DESIGN REVIEW BOARD AGENDA
Community Center
1808 Main Street, Lake Stevens
September 12, 2018

FILE NAME/NO: Frontier Village Shopping Center Design Review / LUA2018-0140
APPLICANT: Lara Barnes, Jackson Main Architecture
LOCATION OF PROPERTY: 519 State Route 9, Lake Stevens WA 98258
ASSESSOR PARCEL NUMBER(S): 00493400300202, 00493400300205
REQUEST: Design Review Approval of Façade Improvements
CONTACT PERSON: Dillon Roth, Associate Planner

FILE NAME/NO: 123rd Ave Townhomes Design Review (LUA2018-0074)
APPLICANT: Larry Thibeault, Lake Stevens Village Townhomes LLC
LOCATION OF PROPERTY: 2309 and 2311 123rd Ave NE, Lake Stevens, WA 98258
ASSESSOR PARCEL NUMBER(S): 00562200000901, 0904, and 0906
REQUEST: Design Review Board Approval
CONTACT PERSON: Dillon Roth, Associate Planner

SHEET TITLE:
PLANTER LANDSCAPE AND IRRIGATION

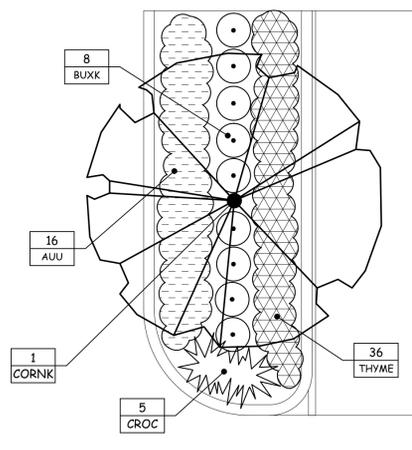
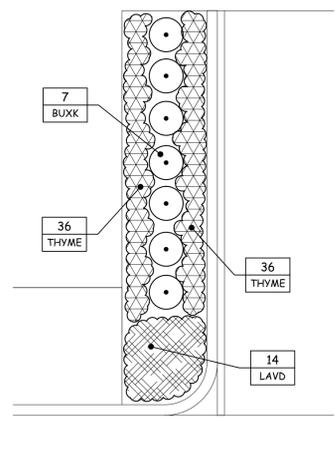
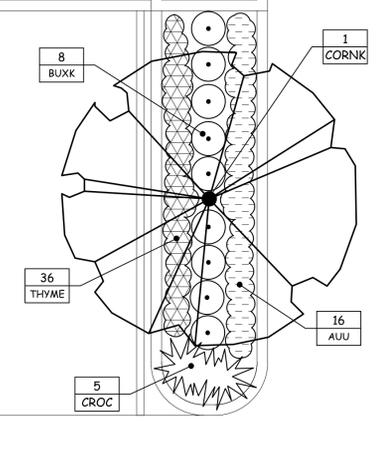
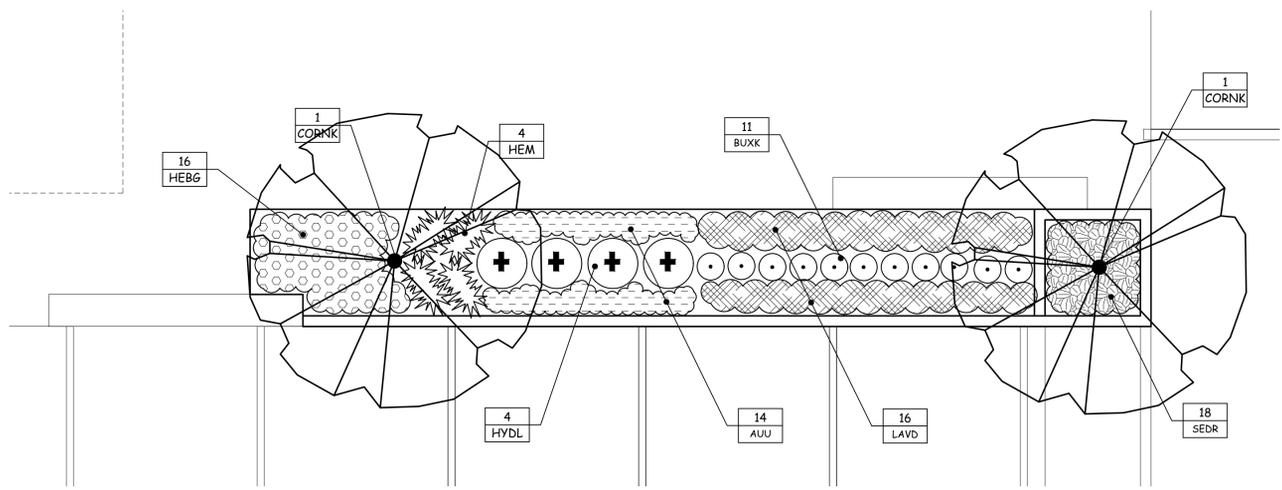
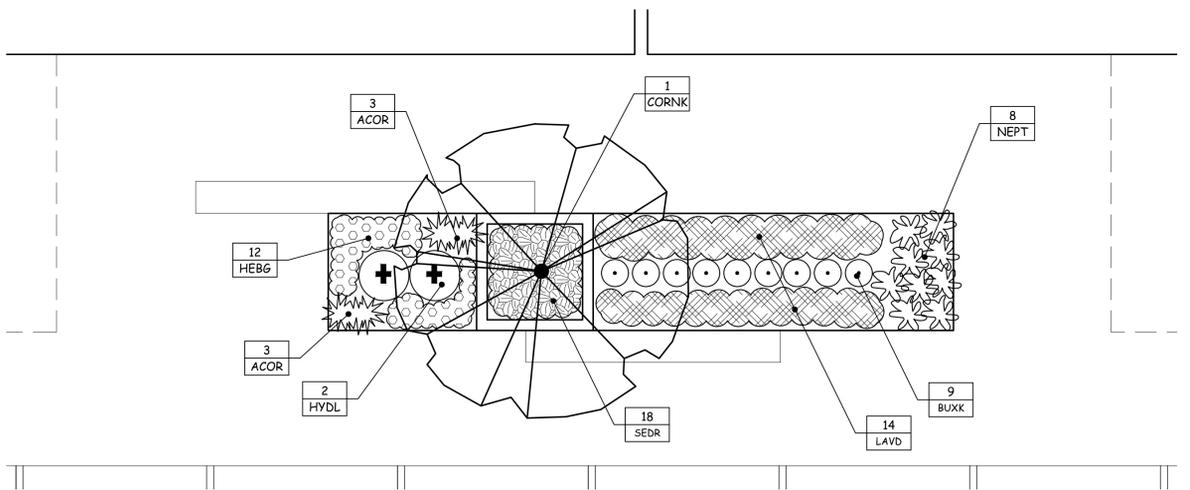
Analysis: The landscaping plan (sheet L-1.0) and the plant photos (sheet L-1.3) show the proposed landscaping for the parking lots, perimeter buffer and around the buildings.

Analysis: Planters A through E incorporate perennial trees and shrubs in the amenity space in front of the existing building. This project is providing a variety of trees shrubs and groundcovers, many of which are native or acclimated to the Northwest.

Analysis: The proposed development has provided a landscaping plan that provides the required landscaping islands at the end of aisles and breaking up runs of parking spaces. Planters C-E include a variety of trees and shrubs that are native or acclimated to the northwest.

LANDSCAPE DESIGN

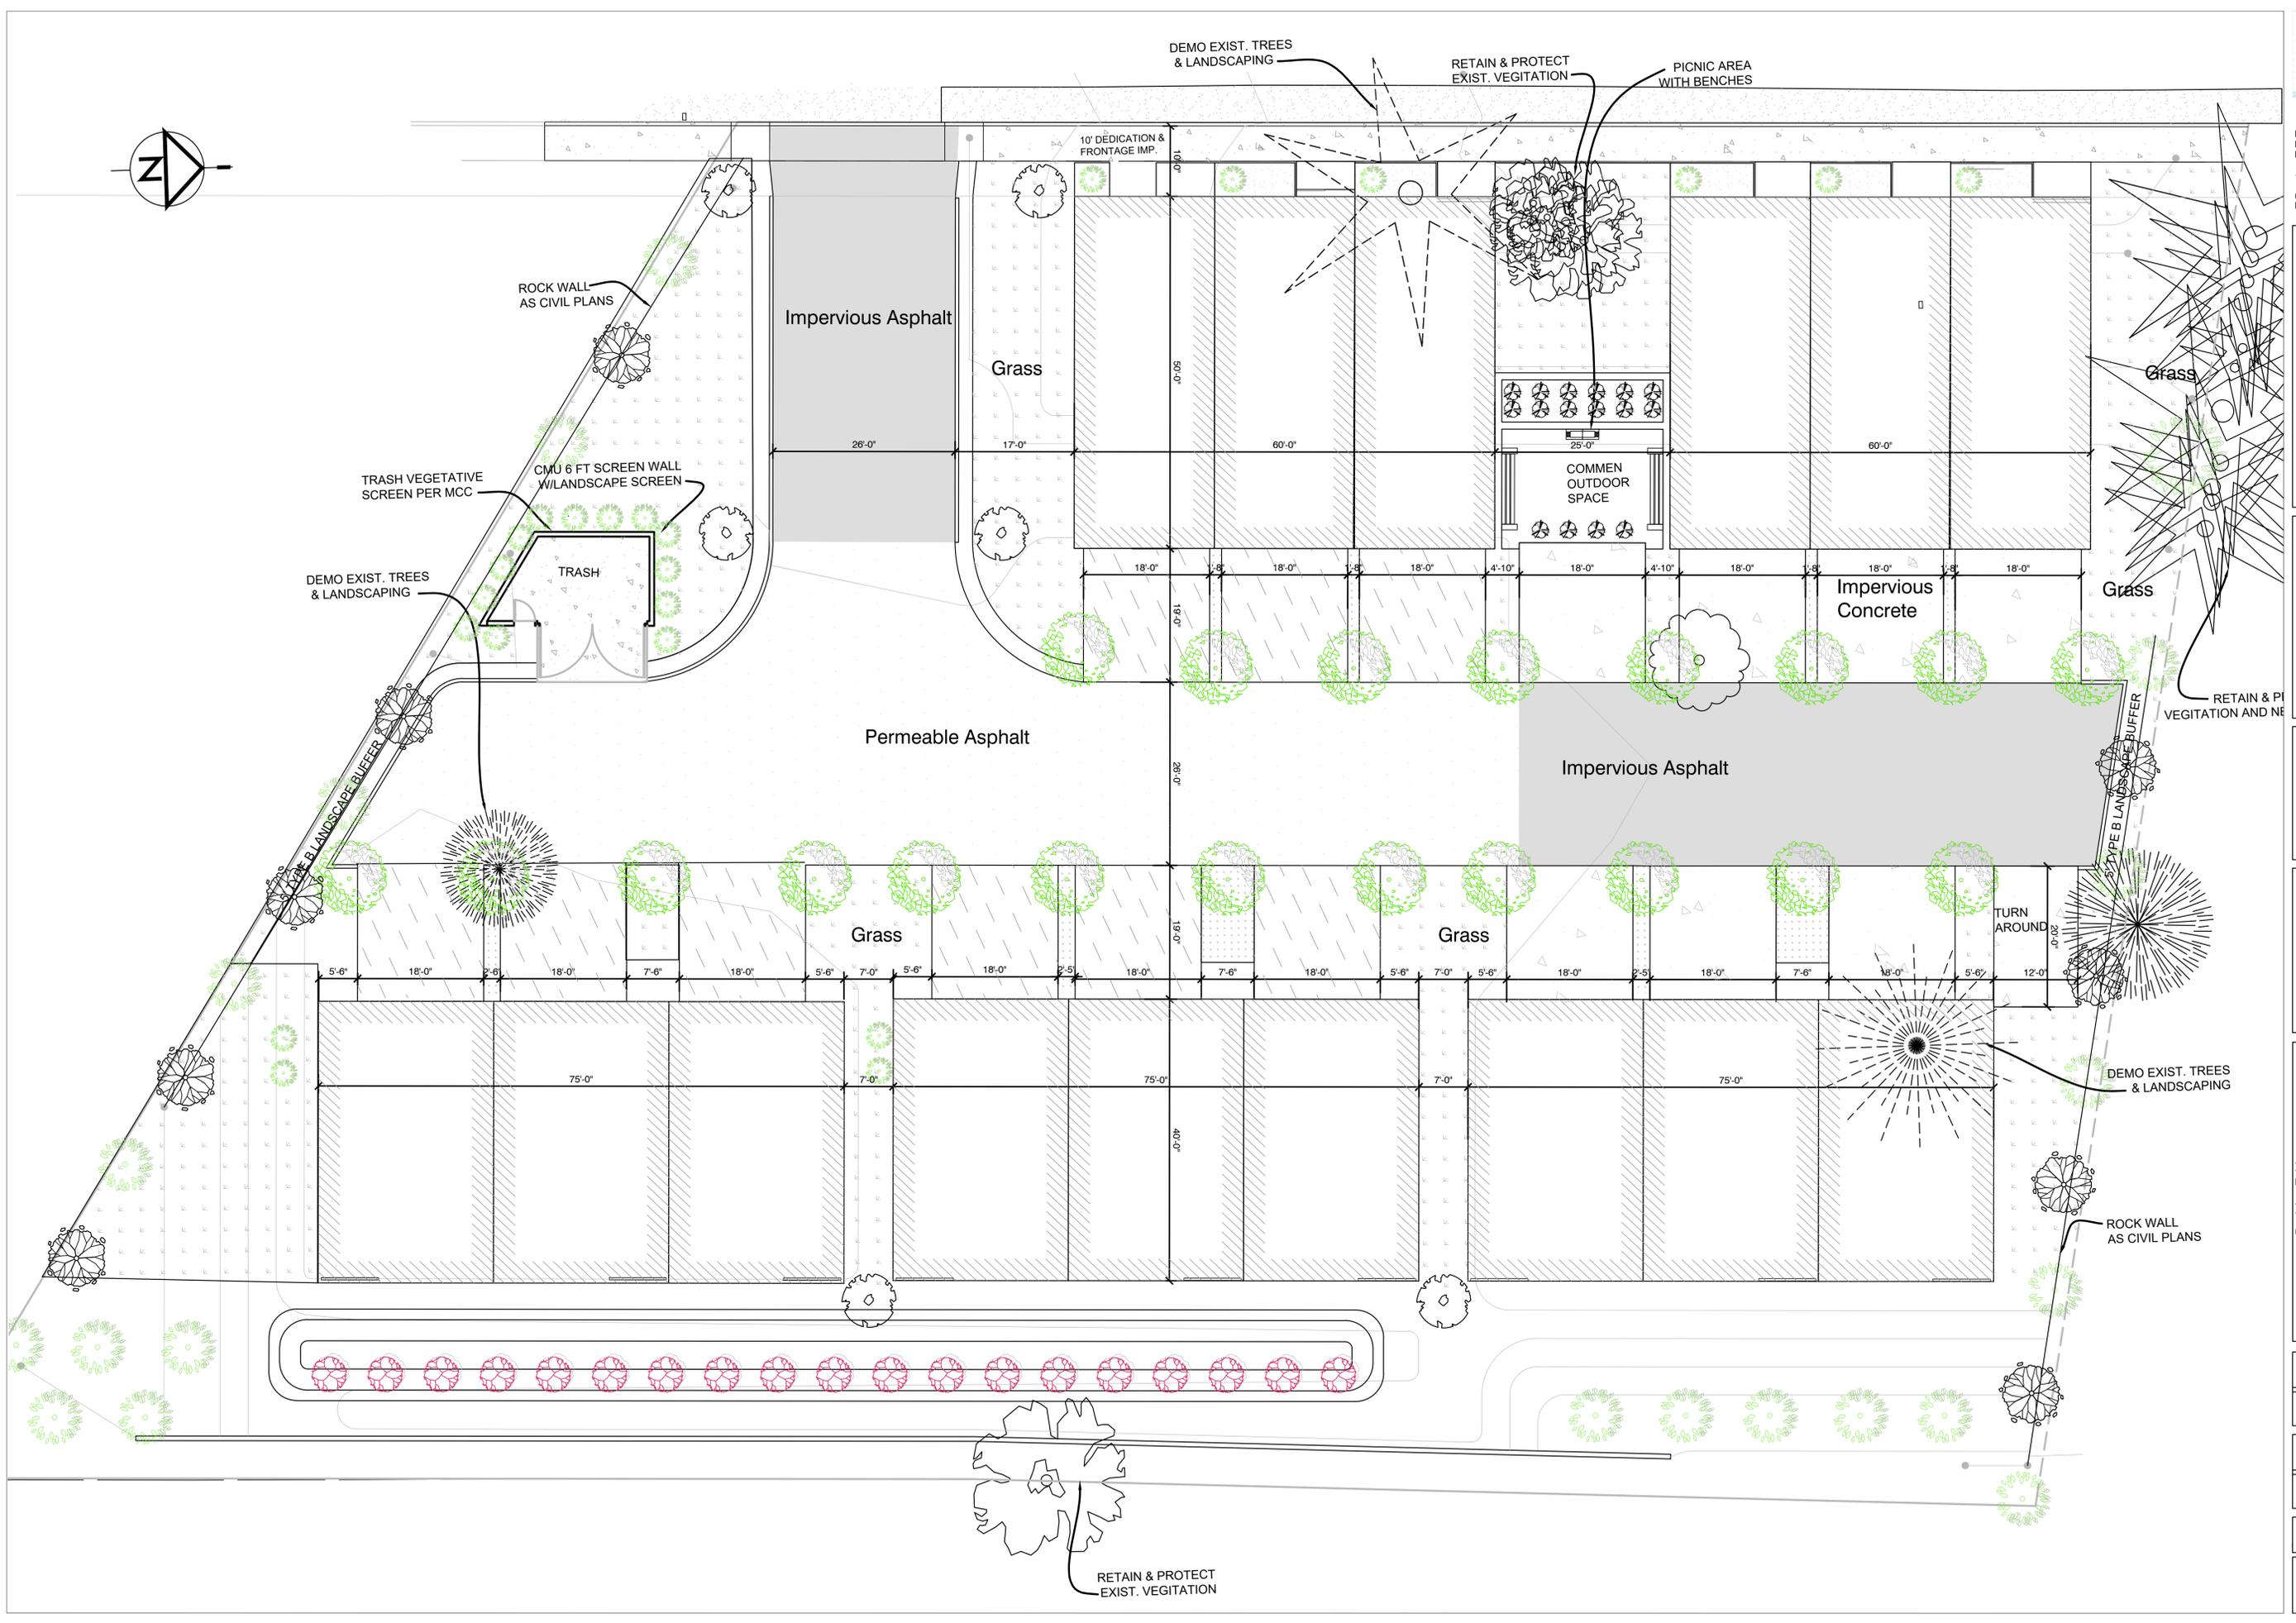
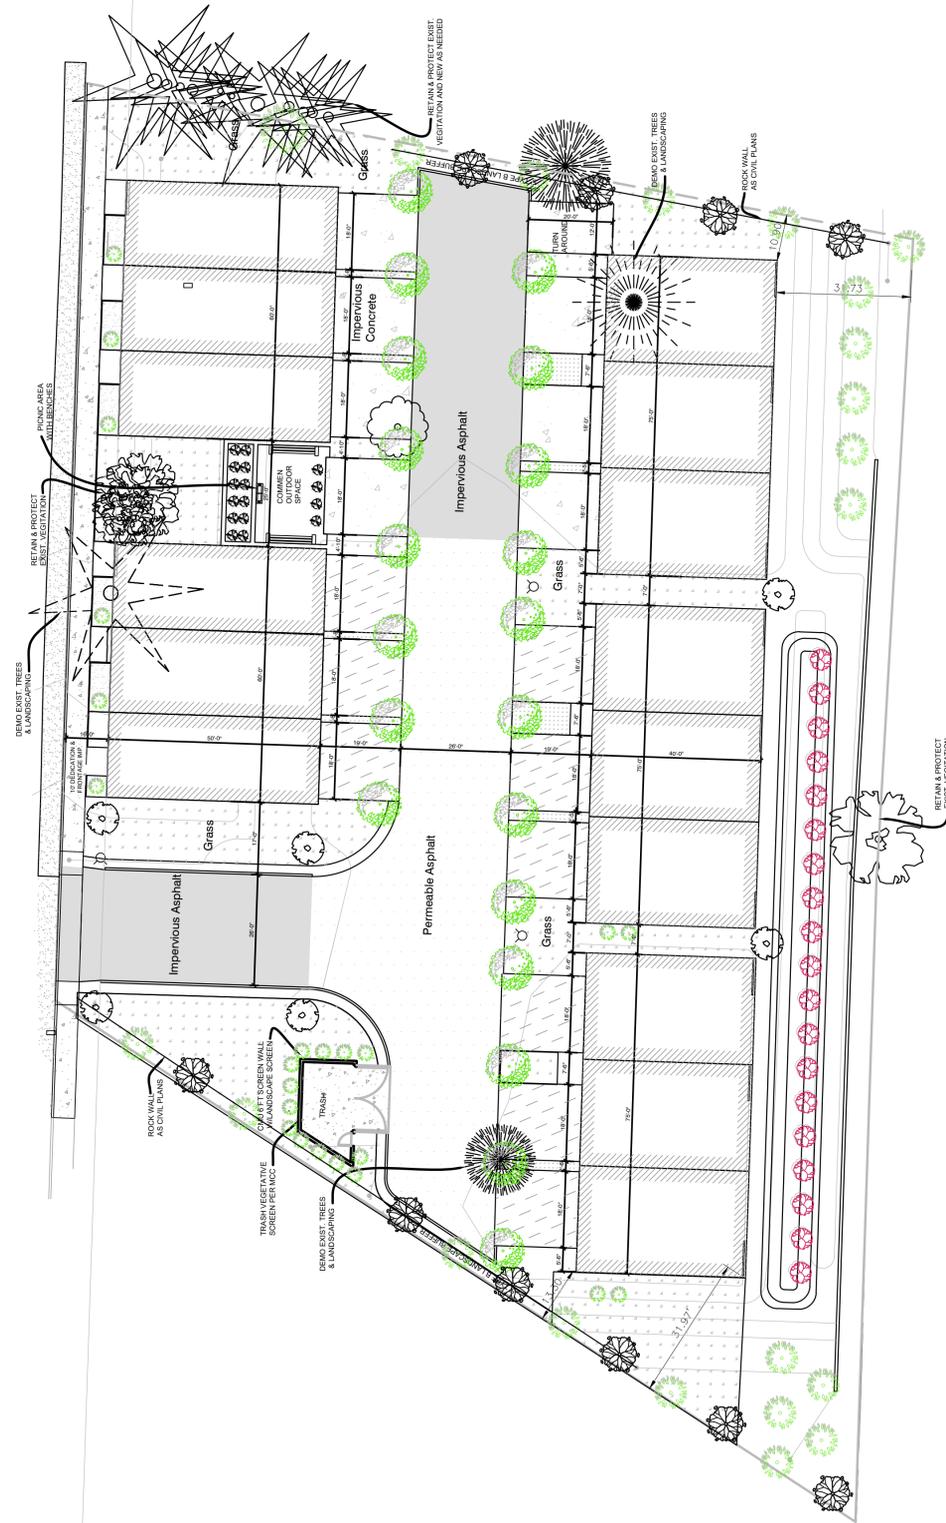
Findings: The landscape plans (**Exhibit 2, Sheets 8-9**) show the landscaped open space, the shading of the parking spaces, the trees to be retained and removed, and the Type B screen.

Findings: The project is proposing to retain several trees onsite in two areas. Existing trees are to be retained in the northwest corner of the project and near 123rd Ave NE in the open space area. The trees in the open space that are proposed to be retained are in an area that is proposed for significant amounts of grading. If it is determined that the existing trees cannot be retained due to the grading in the critical root zone, then staff recommends a condition of approval that requires an appropriate variety of trees be planted in the open space area between the road and the seating area (Condition 6).

of this type of road. Street trees are not shown on the landscape plan set or the site plan set. Therefore, staff is recommending as a condition of approval that an appropriate variety of street tree is proposed along 123rd Ave NE along the subject properties (Condition 4).

4. Street trees shall be planted in the landscape strip in the public right-of-way on 123rd Ave NE as deemed appropriate by the current EDDS standards and Public Works and Planning Departments.

6. The open space area shall be landscaped with an appropriate variety of trees and shrubs between 123rd Ave NE and the seating area.
7. Usable features in the proposed open space area shall include a shared park grill and a picnic table. Substitutes for these features are allowed with the prior approval from the Planning Director.
8. If there is any dispute on the interpretation of these conditions, the issue shall be remanded back to the Design Review Board for final resolution.
